Access Compliance Report Public Rights-of-Way (Curb Ramps)

Main Street: DAWNWOOD Cross Street: WHISPER_CIR Location: E

ADA ID: RPRK211025114732 Ramp Type: Type 4 - Parallel Initial Pass/Fail: Fail Overall Compliance: No Severity Score: 16

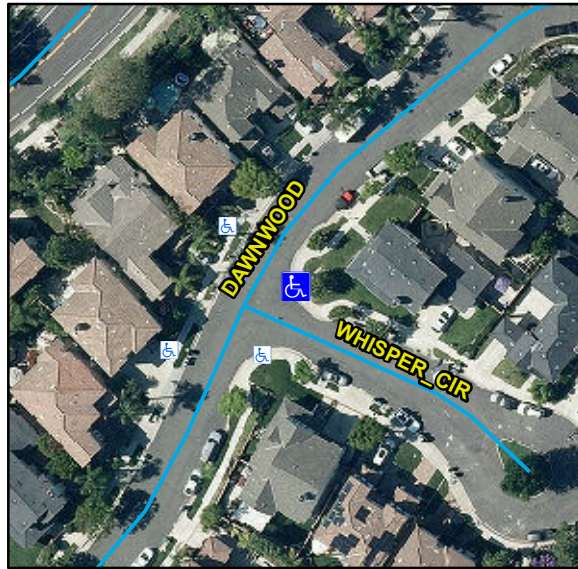
Compliance	Description	Data	Compliance	Description	Data
N/A	Ramp Length LT (in)	114	N/A	Ramp Length RT (in)	112
Yes	Ramp Width LT (in)	54	Yes	Ramp Width RT (in)	54
No	Ramp Run Slope LT (%)	9.3	Yes	Ramp Run Slope RT (%)	3.8
Yes	Ramp Cross Slope LT (%)	1.5	No	Ramp Cross Slope RT (%)	2.2
N/A	Landing Present	N/A	N/A	DWS Provided	N/A
N/A	Landing Length (in)	N/A	N/A	DWS Contrast	N/A
N/A	Landing Width (in)	N/A	N/A	DWS Length (in)	N/A
N/A	Landing Run Slope (%)	N/A	N/A	DWS Full Width	N/A
N/A	Landing Cross Slope (%)	N/A		DWS Offset Type	N/A
N/A	Landing Movement Obstructed?	N/A	N/A	DWS Offset Left (in)	N/A
	Landing Movement Type	N/A	N/A	DWS Offset Right (in)	N/A
N/A	Landing Shared	N/A			
N/A	Clear Space	Yes			
N/A	Clear Space To Crosswalk (in)	N/A			
N/A	Marked Crosswalk 1	No	N/A	Marked Crosswalk 2	No
	Crossing 1 Direction	NW		Crossing 2 Direction	SW
	Marked Crosswalk 1 Width (in)	N/A		Marked Crosswalk 2 Width (in)	N/A

Remove & Replace Curb Ramp With Two New Directional Ramps or Equivalent.
